Re: Indian Point Unit No. 2
Docket No. 50-247
NL-00-099

Subject: Responses to the NRC's Request For Additional Information Regarding
Steam Generator Operational Assessment Report (TAC No. MA9288)

RESPONSES TO THE RAI QUESTIONS FROM NRC LETTER DATED JULY 20, 2000

**Figure RAI-1-1. Indian Point-2: POD vs. Burst Effective Crack Area
Nominal, Lower 95% and Lower 99% Confidence Levels**

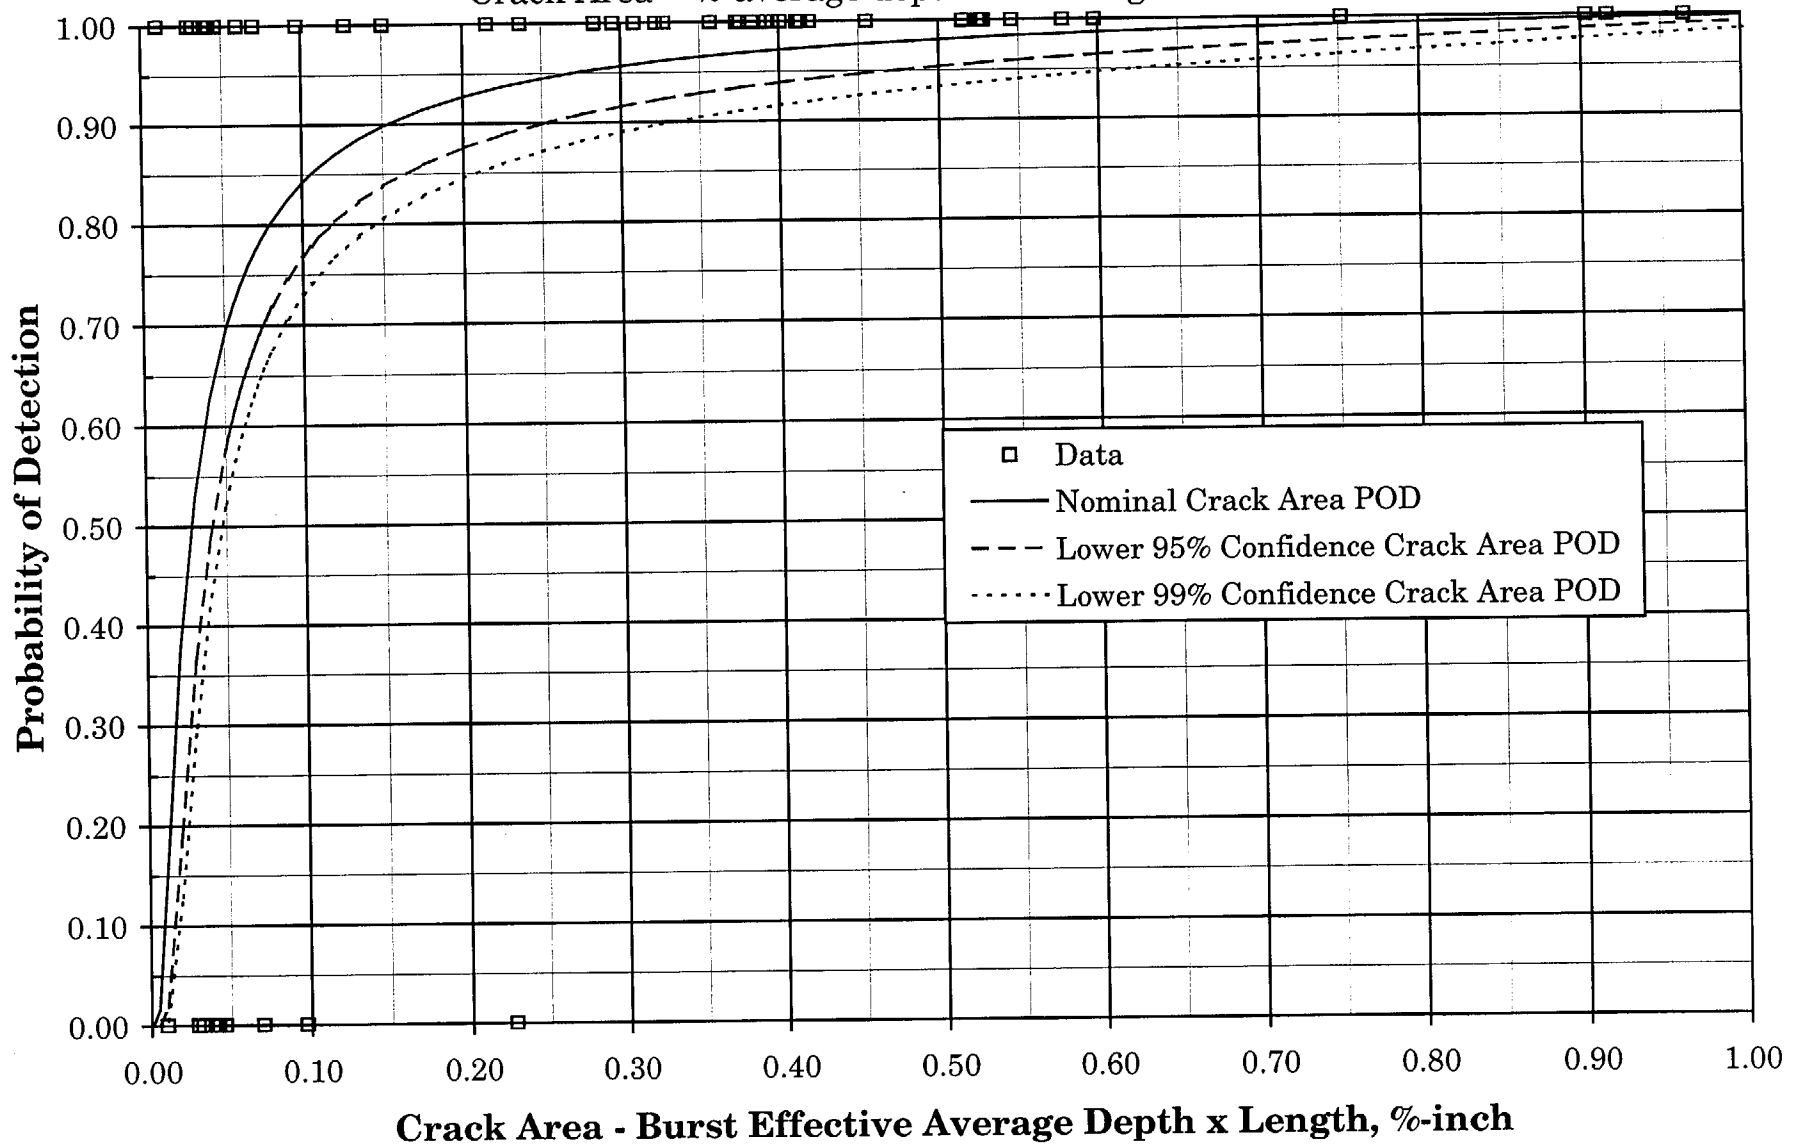
The July 7, 2000, submittal from Consolidated Edison Company of New York, Inc. (the licensee) refers to the consideration of an uncertainty distribution that was applied to the depth-based and area-based probability of detection (POD) curves for the low row U-bends. Confirm whether the staff's understanding is correct that the assumed uncertainty distribution refers to the full uncertainty range of the nominal fit to the data. Provide a chart illustrating the 95 percent confidence bounds on the nominal POD fit to the crack area data (similar to that done in Figure 6-1 for the nominal fit to average crack depth).

Figure RAI-1-1 provides the requested plot of the nominal and lower 95% confidence POD fit to the crack area data. The plot also includes the lower 99% confidence POD curve. The lower 99% confidence curve is included to permit comparisons of a defined confidence level with the Question 3 request to provide sensitivity analyses for a 50% and 100% shifts of the nominal crack area based POD function.

Figure RAI-2-1. Indian Point-2: POD vs. Average Crack Depth Including PODs at Lower Confidence Levels and with Depth Shifts

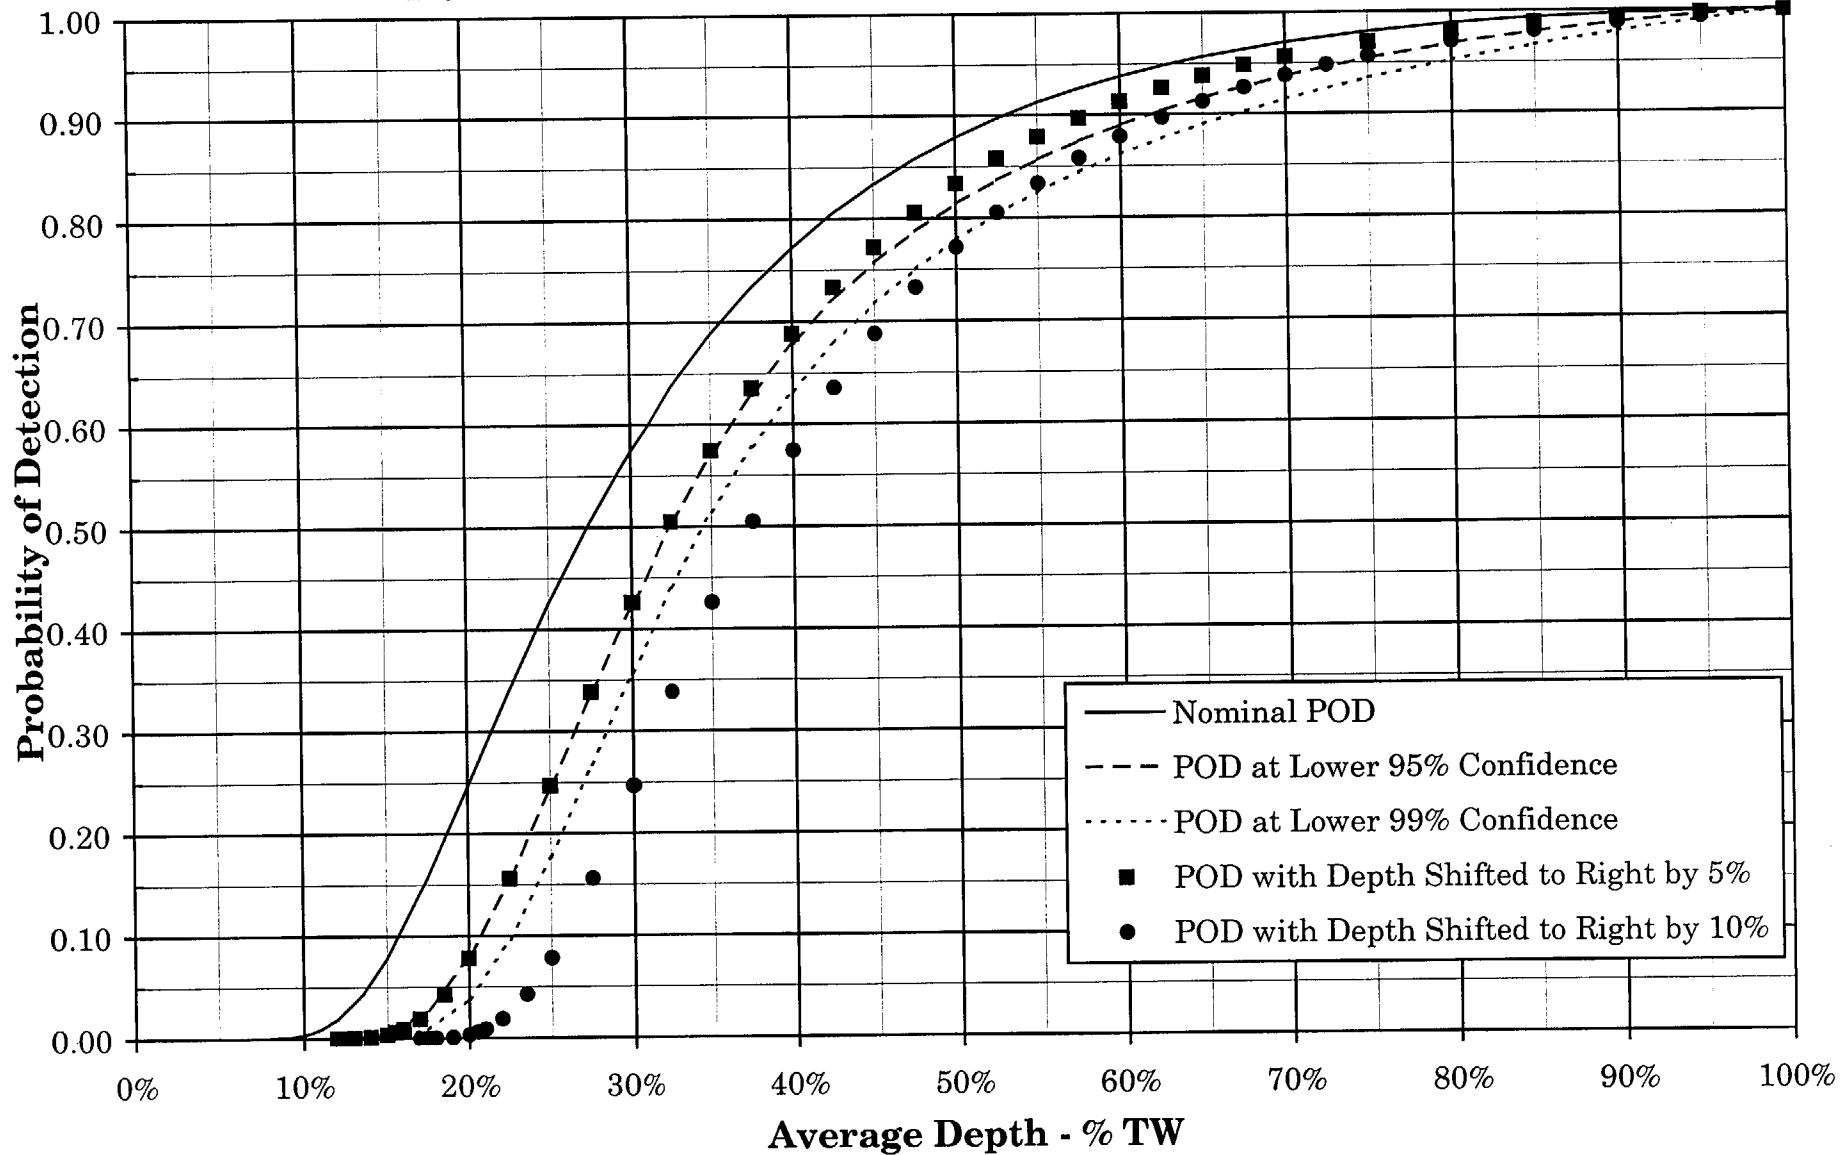
In its June 2, 2000 submittal, the licensee had previously provided the analysis sensitivity results for an assumed +5% shift of the depth-based POD in terms of percent through-wall. What is the sensitivity of the June 2 analysis to a 10% shift?

The 5% and 10% shifts in the nominal depth-based POD function are obtained by adding 5% and 10% average depth to the nominal depth at each POD value. This provides a lateral shift in the POD by 5% and 10% depth to more conservative POD functions. In Figure RAI-2-1, the nominal and shifted PODs are compared with the average depth POD uncertainty distribution evaluated at the lower 95% and lower 99% confidence levels. The POD with a 5% depth shift is in good agreement (about 1 to 2% in POD higher above 45% depth) with the POD evaluated at the lower 95% confidence level. However, including this POD in the Monte Carlo analyses is equivalent to deterministically applying the lower 95% POD for all indications. This practice is much more conservative than the required evaluation of the burst distribution at a 95/95 confidence level including POD uncertainties in the analysis. The POD with a 10% average depth shift is more conservative than the POD at the lower 99% confidence level for crack depths less than 50% and slightly less conservative (1 to 2% on POD) for crack depths above 55%. It should be noted that analyses at 99% or greater confidence levels are unprecedented in the level of conservatism (statistical 99% and even more conservative for deterministic 99% POD applications) for SG tube integrity analyses by any existing NRC or EPRI or other industry guidelines. As a result, such analyses are not considered applicable or necessary for assessing the Indian Point-2 acceptable operating cycle length.

**Figure RAI-3-1. Indian Point-2: POD vs. Burst Effective Crack Area
Including PODs at Lower Confidence Levels and with Crack Area Shifts**

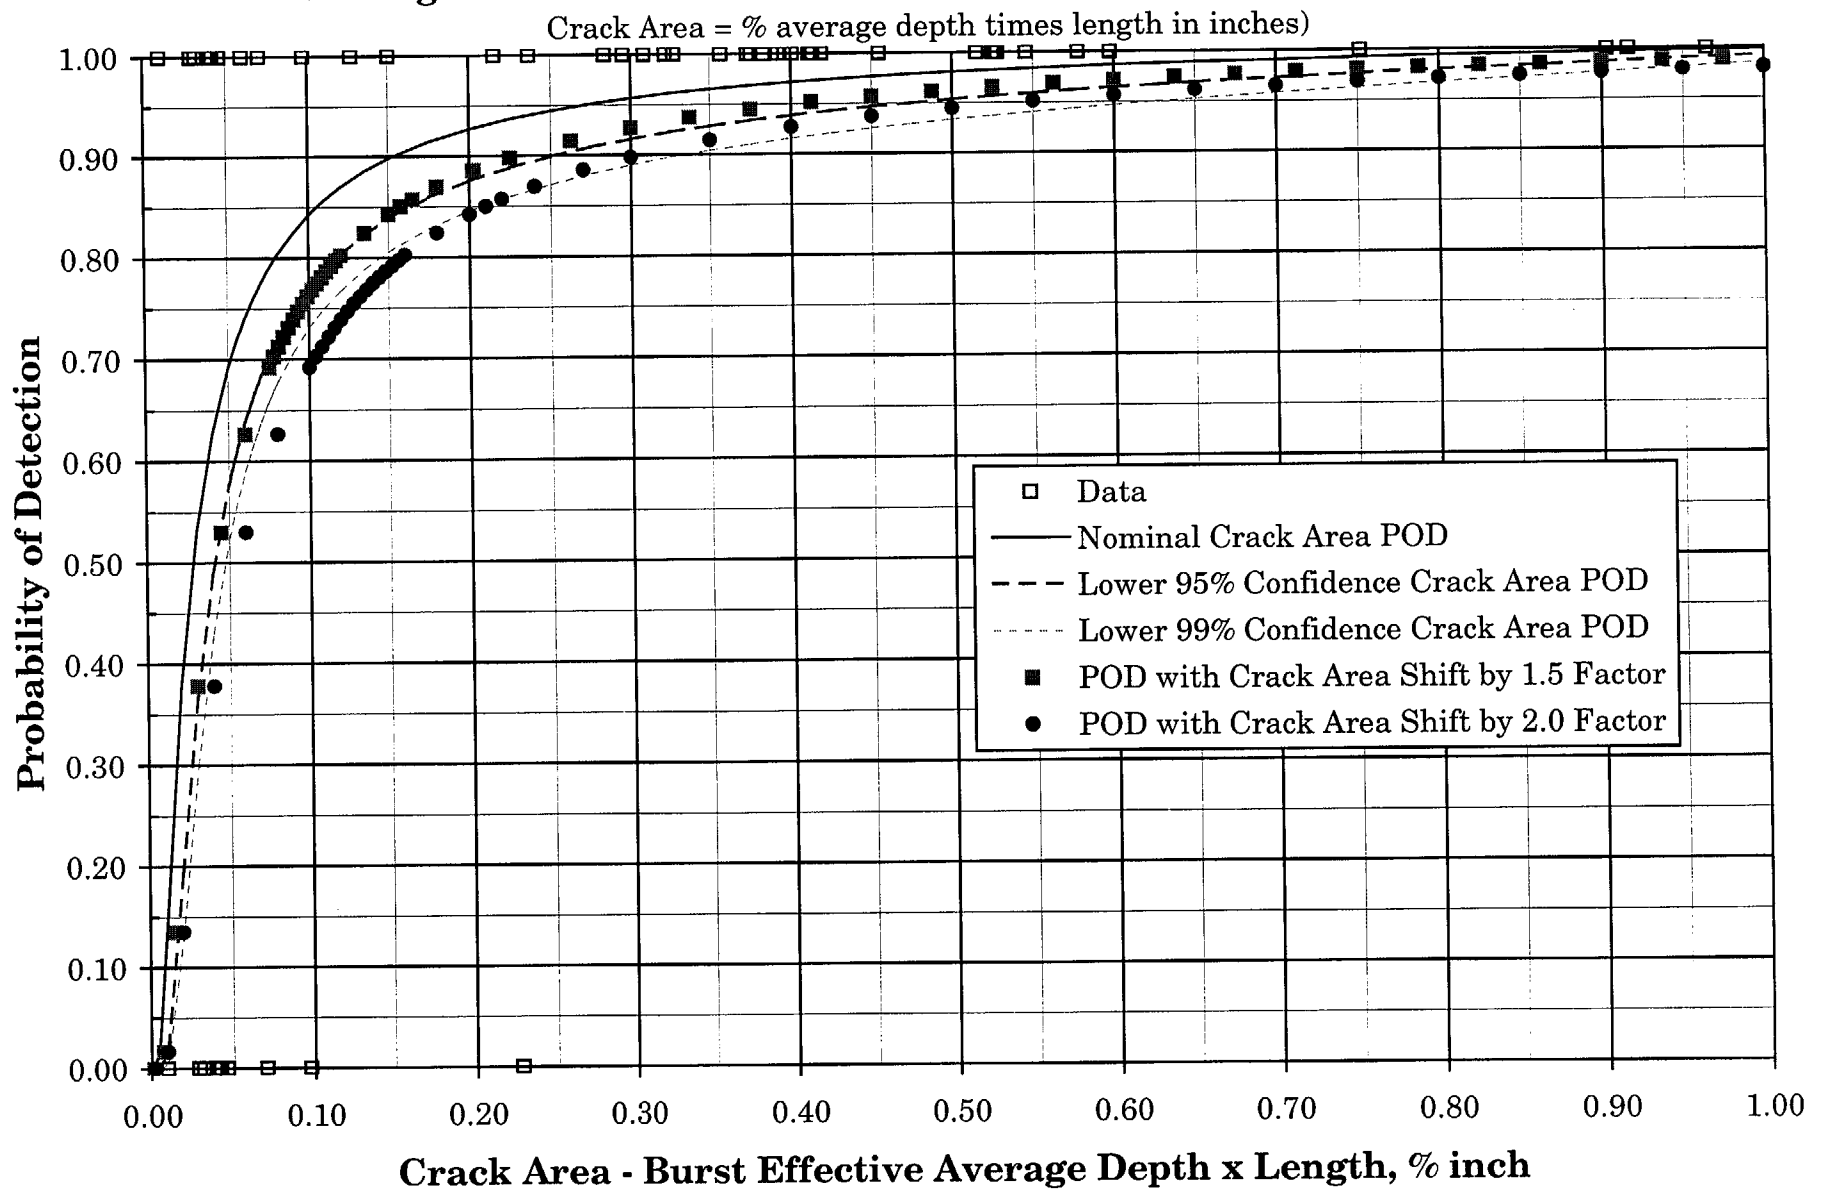
In its July 7 submittal, the licensee did not describe the sensitivity of the supplemental analysis results to a shift in the nominal crack area-based POD function. Provide the sensitivity of the analysis results to a 50% and 100% shift of the nominal area-based POD function in terms of crack area for a given POD value.

The 50% and 100% shifts in the nominal area-based POD function are obtained by multiplying the nominal area at each POD value by factors of 1.5 and 2.0, respectively. This provides a lateral shift in the POD conceptually similar to that for the 5% and 10% shifts in the POD for Question 2 above. In Figure RAI-3-1, the nominal and shifted PODs are compared with the POD uncertainty distribution evaluated at the lower 95% and lower 99% confidence levels. The crack area POD with a 1.5 factor shift is in good agreement (1% on POD) with the POD evaluated at the lower 95% confidence level.

The crack area POD with a 2.0 factor shift is more conservative than the POD at the lower 99% confidence level for crack areas less than 0.25 and slightly less conservative (1 to 2% on POD) for crack areas above 0.25. The row 2 indications found in the year 2000 inspection have crack areas of 0.03 to 0.14 %-inch for the 8 smaller indications and 0.29 to 0.46 %-inch for the 3 largest indications. Analyses at 99% or greater confidence levels are unprecedented in the level of conservatism for SG tube integrity analyses required by any NRC or EPRI guidelines, and are not considered appropriate for assessing the Indian Point-2 acceptable operating cycle length.
